# Illinois Department of Transportation

SUBJECT FAI Route 94 (I-94/Bishop Ford Expwy)  
Section (42-B-11-1) BR,BJR 24  
Project NHPP-2B1H(072)  
Cook County  
Contract No. 62W87

Item No. 205, April 25<sup>th</sup>, 2025 Letting  
Addendum A

## NOTICE TO PROSPECTIVE BIDDERS:

**IDOT DISTRICT 1 LUMINAIRE PERFORMANCE TABLE 1**  
**ROADWAY UNDERPASS LIGHTING**  
**1 LANE**

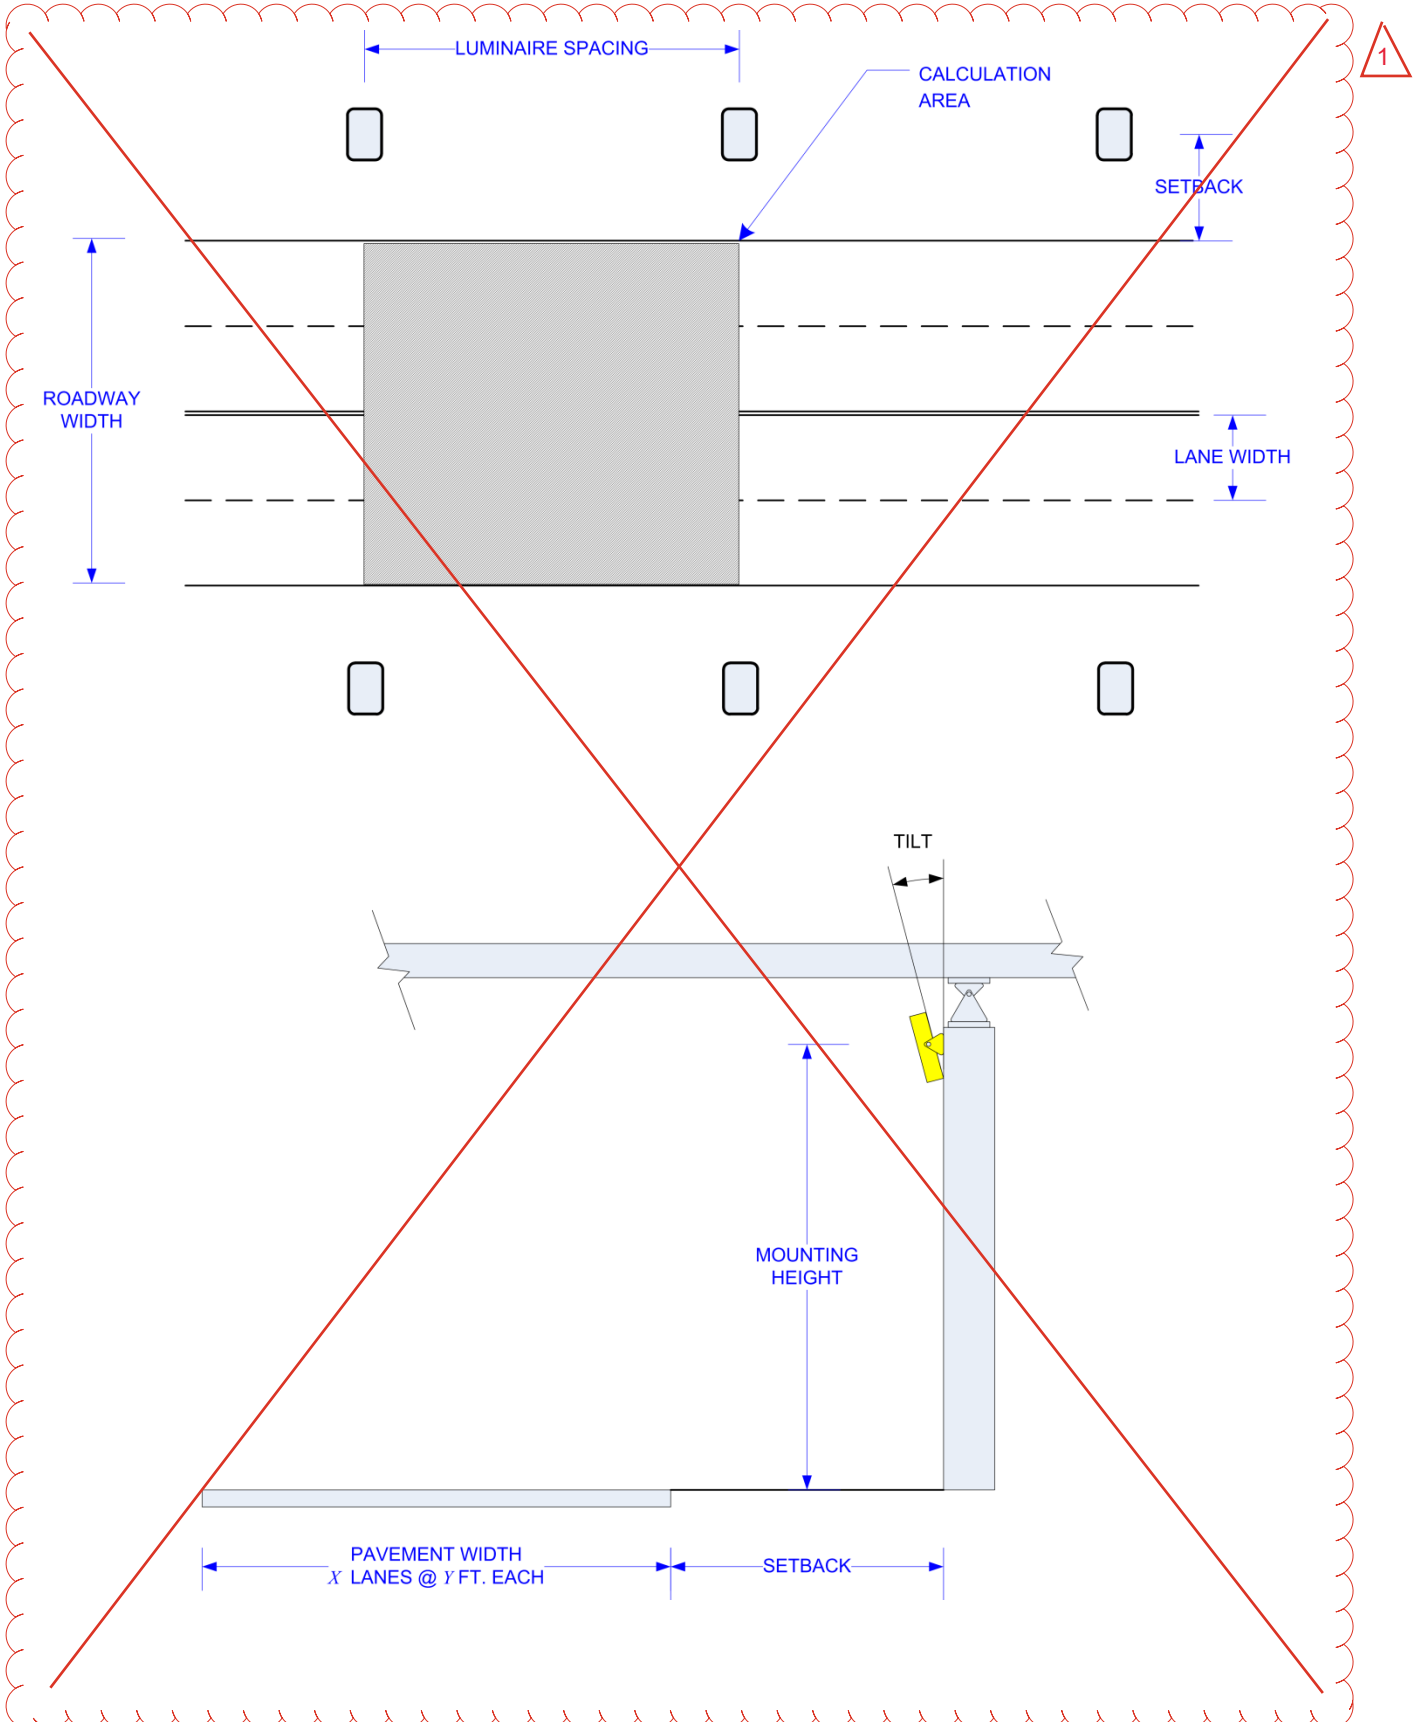
~~2 LANE~~

**~~IDOT DISTRICT 1 LUMINAIRE PERFORMANCE TABLE 3~~**  
**~~ROADWAY UNDERPASS LIGHTING~~**

**~~3 LANE~~**

ROADWAY	Average Luminance, $L_{AVE}$	1.6	Cd/m <sup>2</sup> (Max)
		1.2	Cd/m <sup>2</sup> (Min)
LUMINANCE	Uniformity Ratio, $L_{AVE}/L_{MIN}$	3:1	(Max)
	Uniformity Ratio, $L_{MAX}/L_{MIN}$	5:1	(Max)
	Veiling Luminance Ratio, $L_v/L_{AVE}$	0.30:1	(Max)

**IDOT DISTRICT 1 LUMINAIRE PERFORMANCE TABLE 5**  
**ROADWAY UNDERPASS LIGHTING**  
**5 LANE**

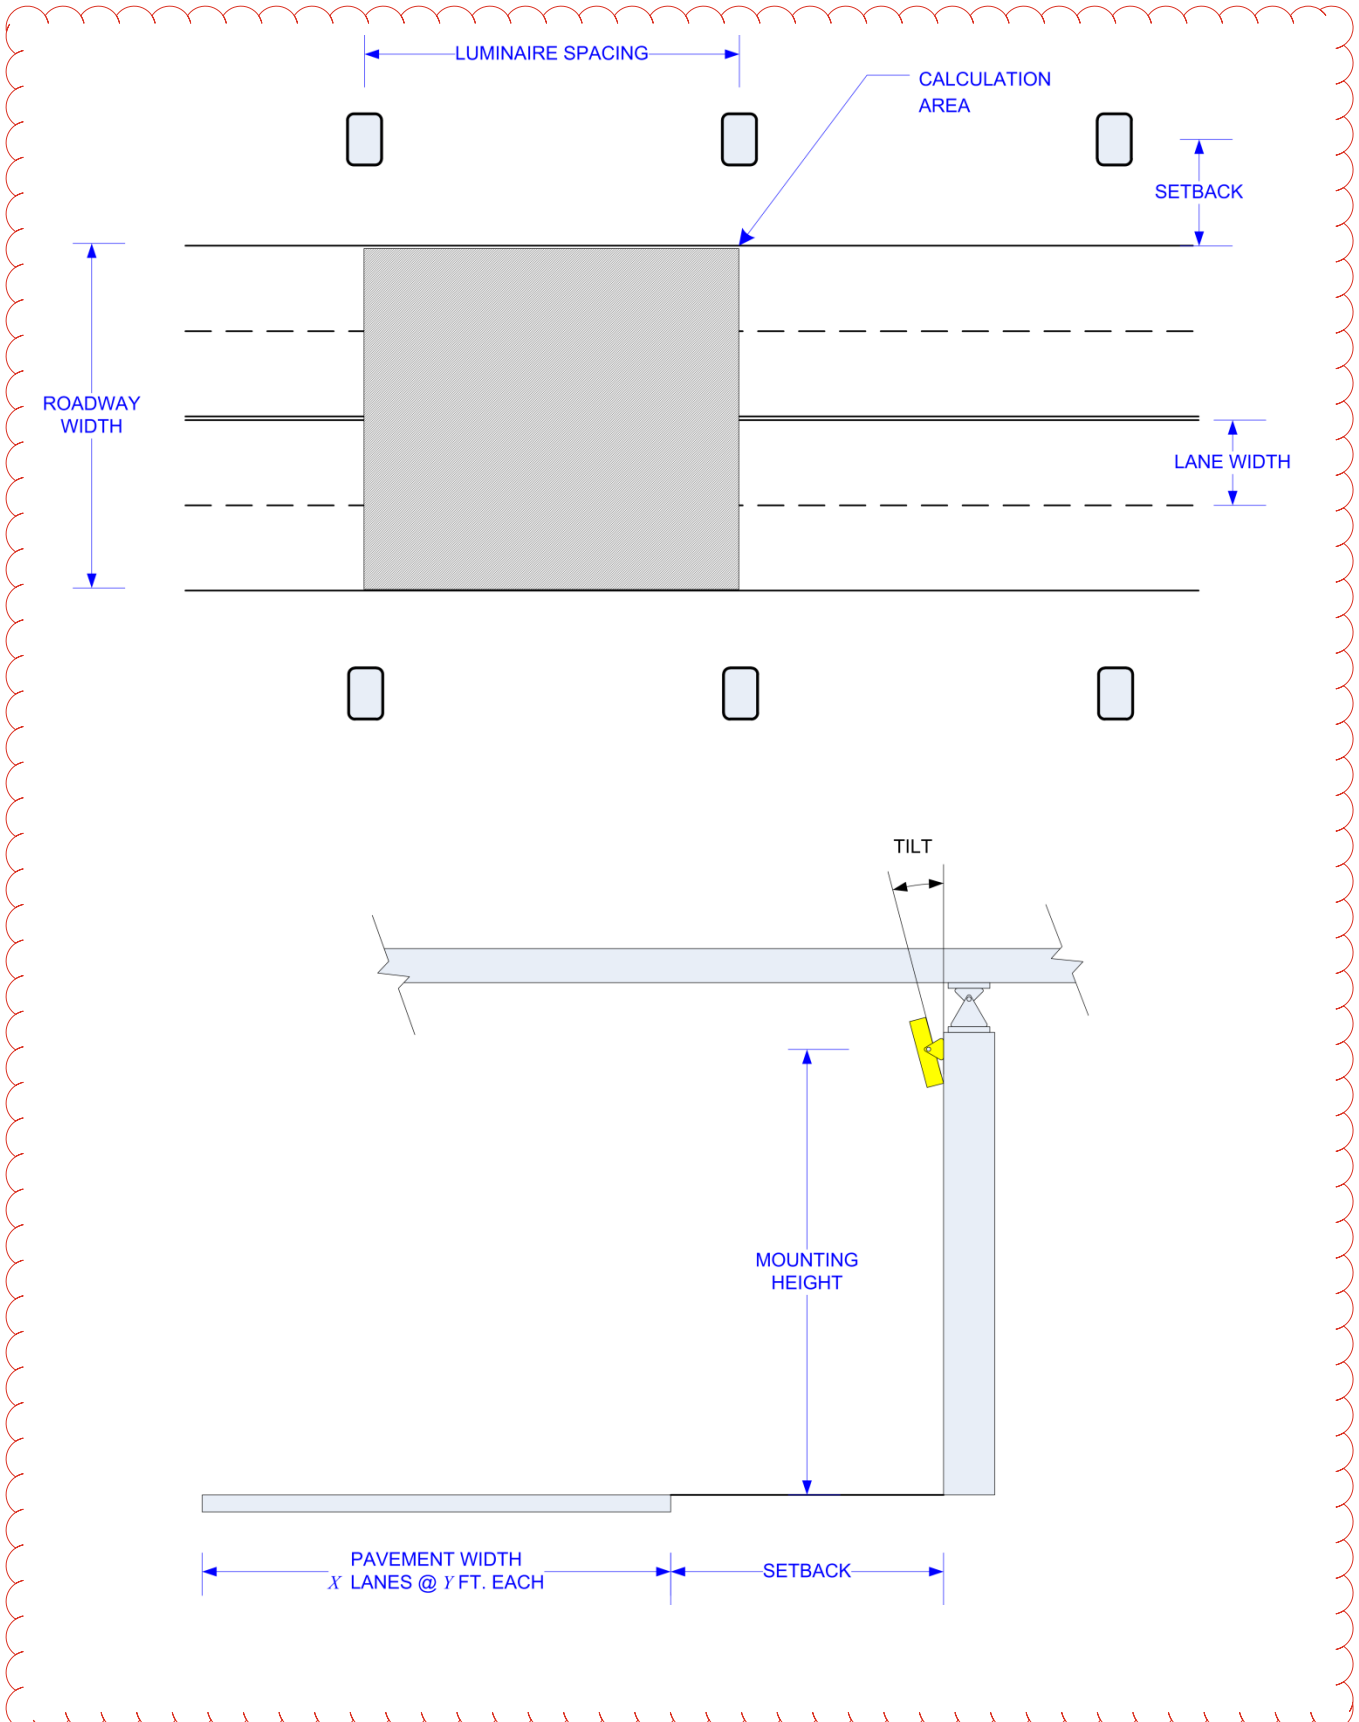
This work shall consist of furnishing and installing a replacement underpass LED luminaire as shown on the plans, as specified herein. The existing luminaires are LPS and are suspended typically with two threaded rods. The replacement luminaires shall include and adapted plate if needed and all other materials to install the proposed luminaries on the existing threaded rods. The existing raceways and cabling shall be re-used.

GIVEN CONDITIONS			
<b>ROADWAY DATA</b>	Pavement Width	60	(ft)
	Number of Lanes	5	
	I.E.S. Surface Classification	R3	
	Q-Zero Value	.07	
<b>MOUNTING DATA</b>	Mounting Height	15	(ft)
	Tilt	0-15	(degrees)
	Orientation	Perpendicular to roadway	
	Set-Back from Edge Of Pavement	12	(ft)
<b>LUMINAIRE DATA</b>	Lumens	10,000 – 13,500	
	Total Light Loss Factor	0.65	
<b>LAYOUT DATA</b>	Spacing	40	(ft)
	Configuration	Opposite	
	Luminaire Overhang over EOP	-12	(ft)
